♦ ♦ ♦ ♦ **ADDENDUM TO BID** ♦ ♦ ♦ ♦

PRE-ENGINEERED METAL BUILDING

Bid Title: PRE-ENGINEERED METAL BUILDING
Bid No.: 15-5300.PRE-ENGINEERED METAL BUILDING
Addendum No.: 1
Issued: November 21, 2014

ADDENDUM TO: Pre-Engineered Metal Building
Bid No. 15-5300.PRE-ENGINEERED METAL BUILDING (Lube Center)
2:00 p.m., December 2, 2014

ISOMETRIC VIEWS

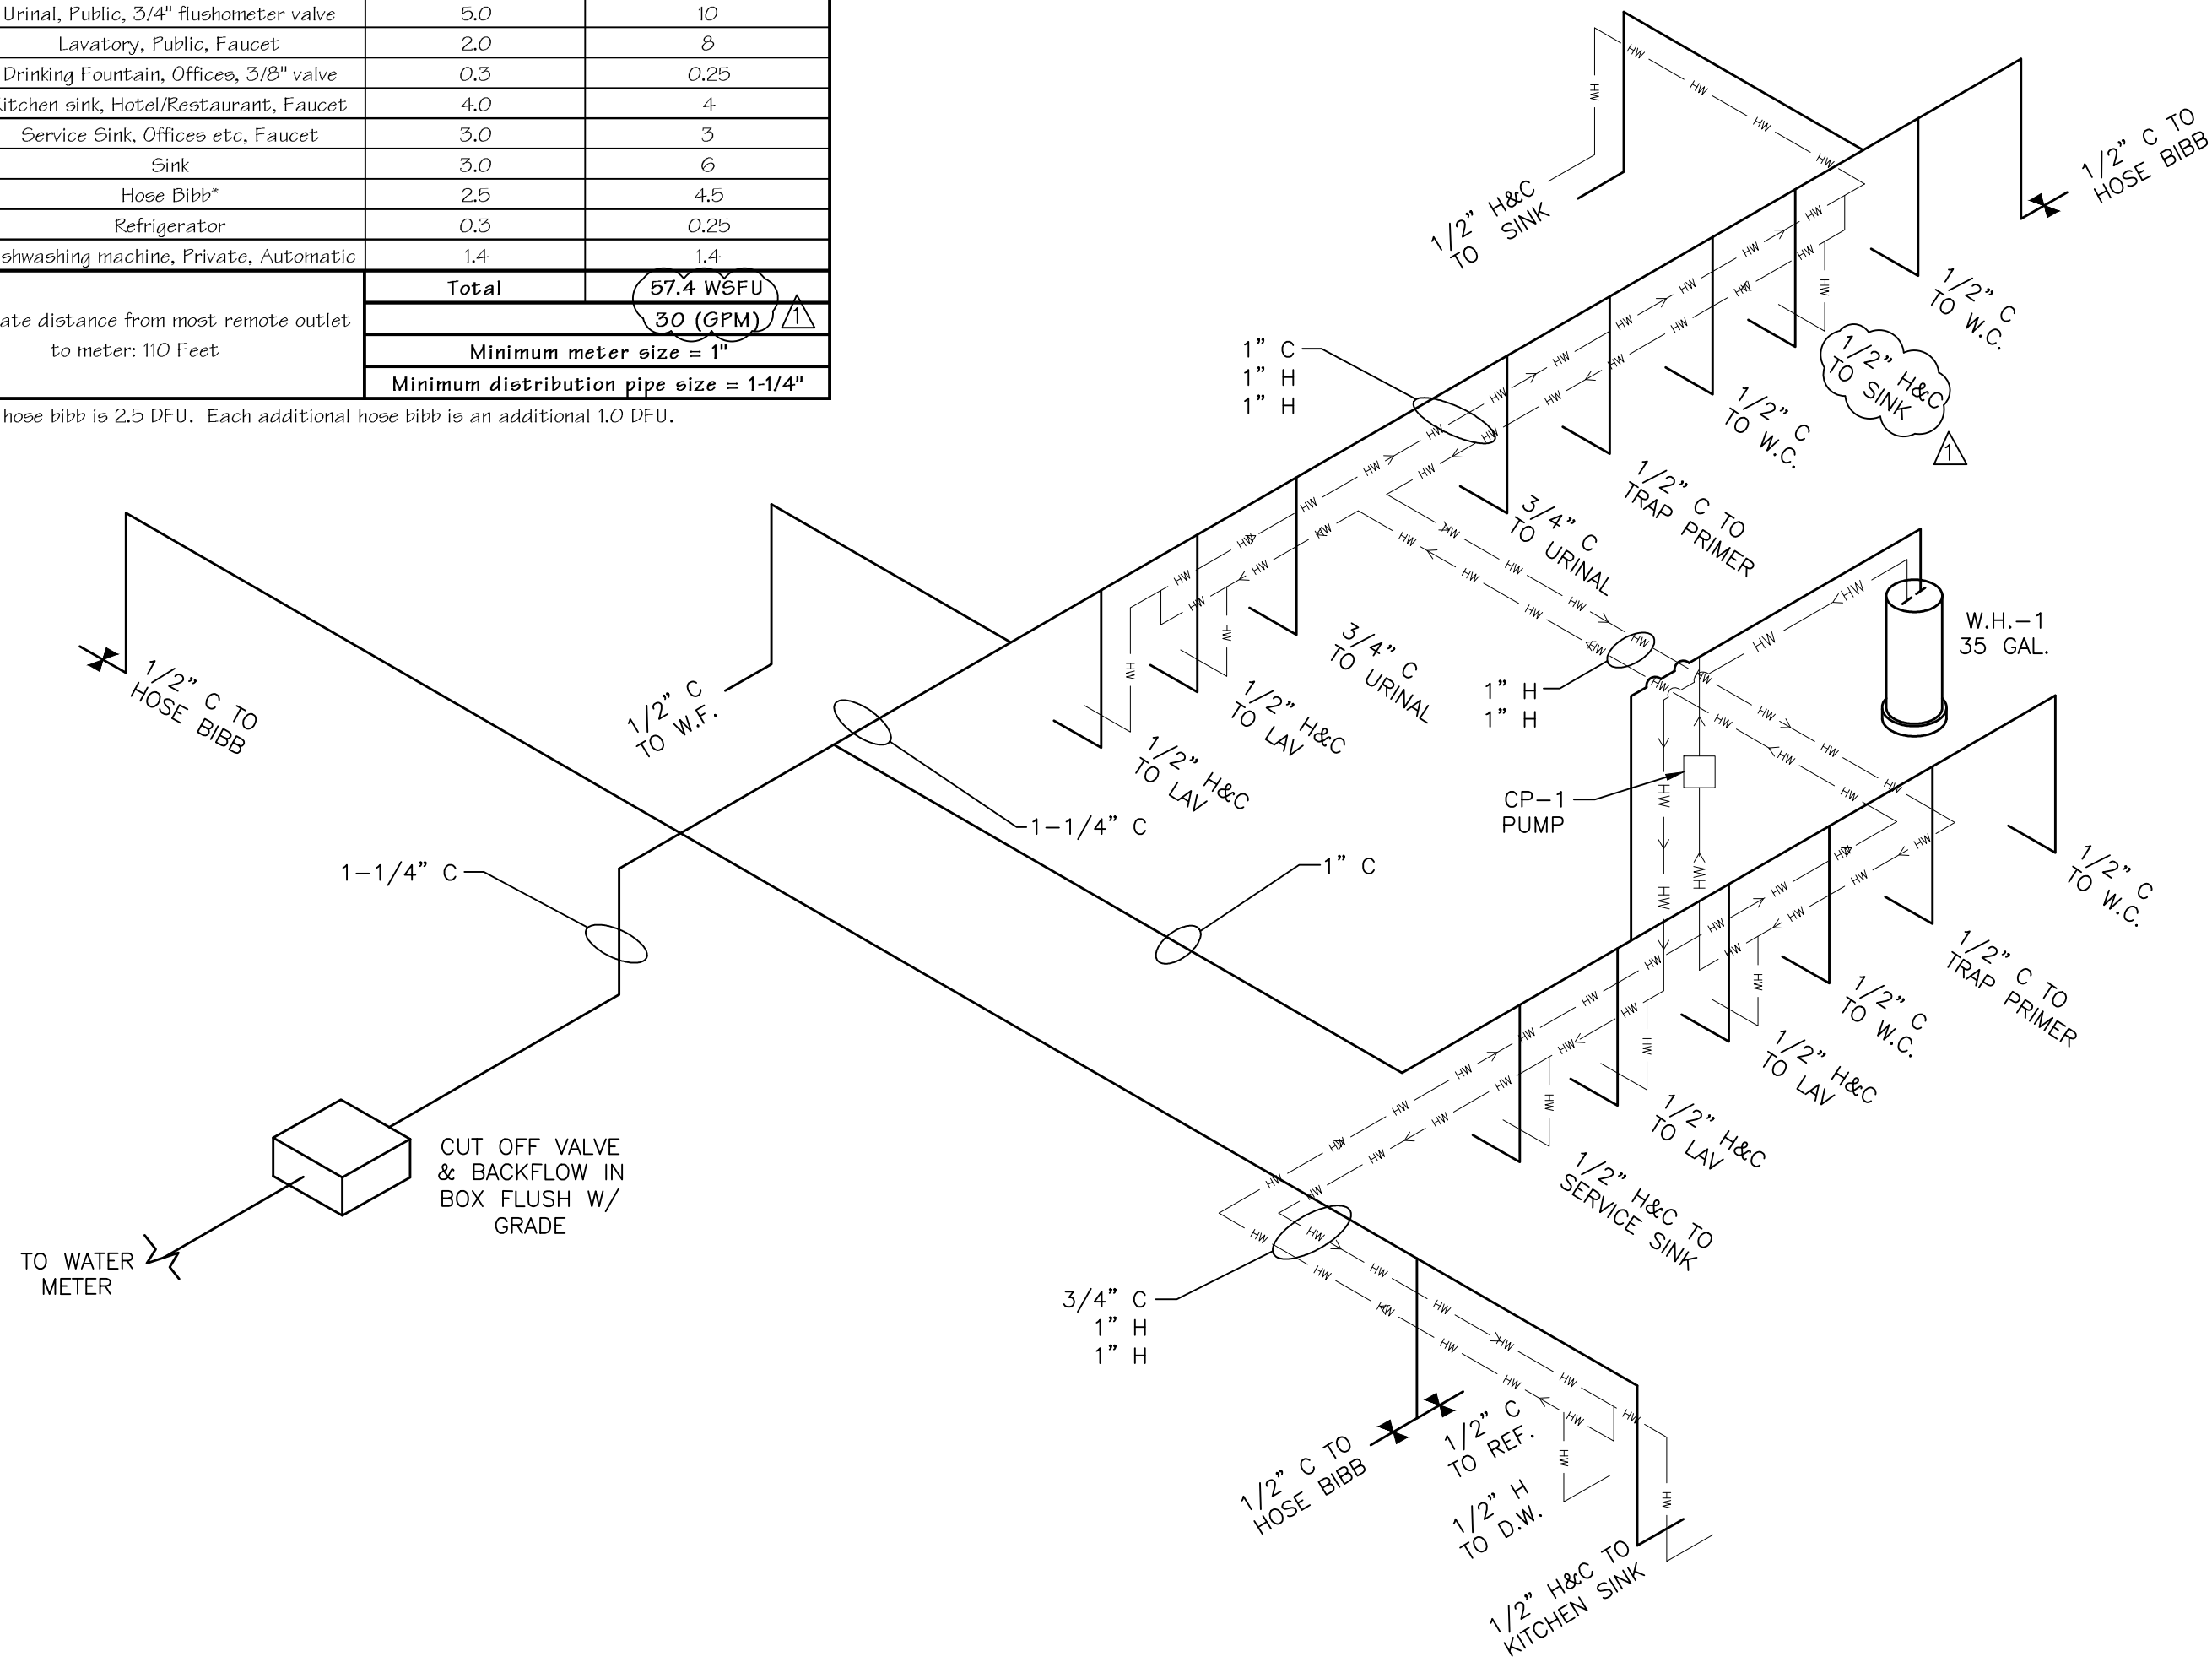
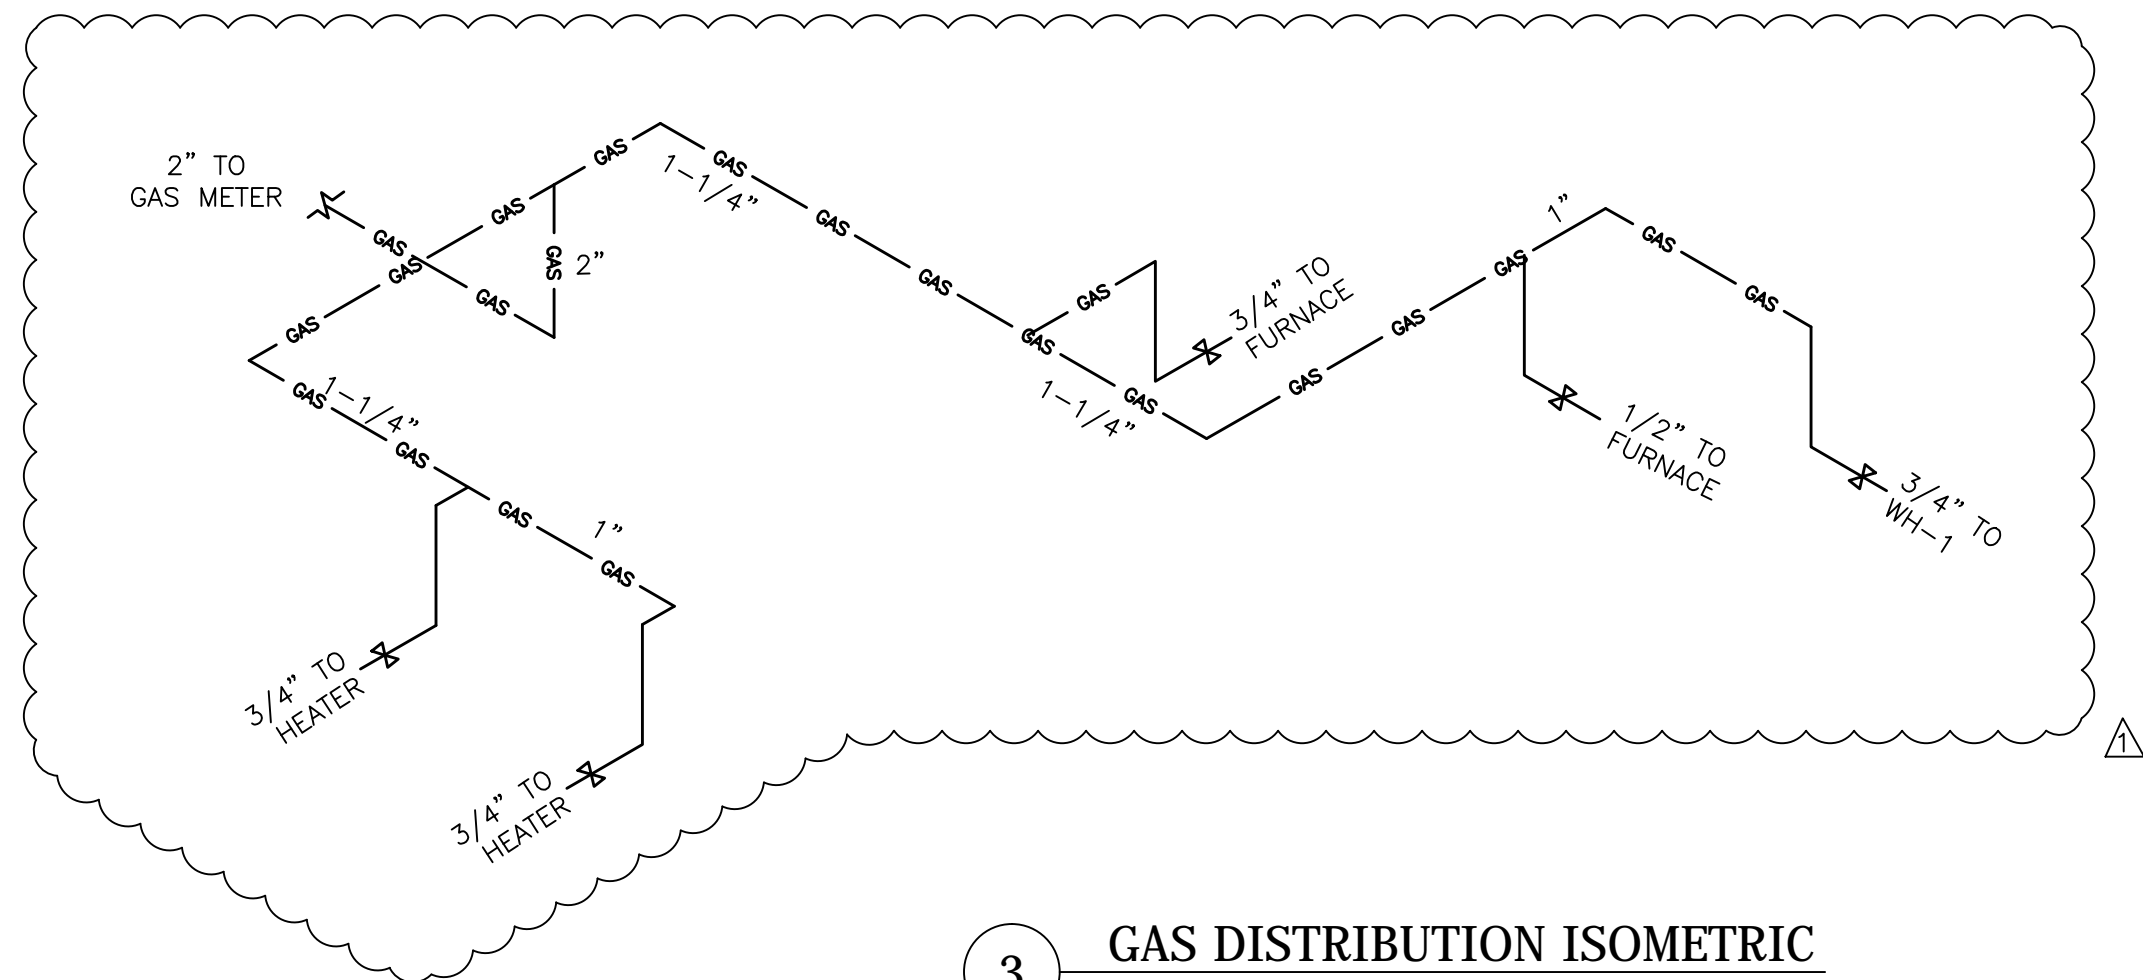
UPDATED PROPOSED NATURAL GAS DEMAND TABLE. UPDATED SIZES ON GAS PIPING. UPDATED LAV TO SINK IN RESTROOM. UPDATED QUANTITIES IN FIXTURE UNIT COUNT TABLES.

Response: Yes. Gas piping was originally sized for supply pressure of 2psi. To avoid regulators, we re-sized the piping for 4oz supply pressure. Please see attached drawings.
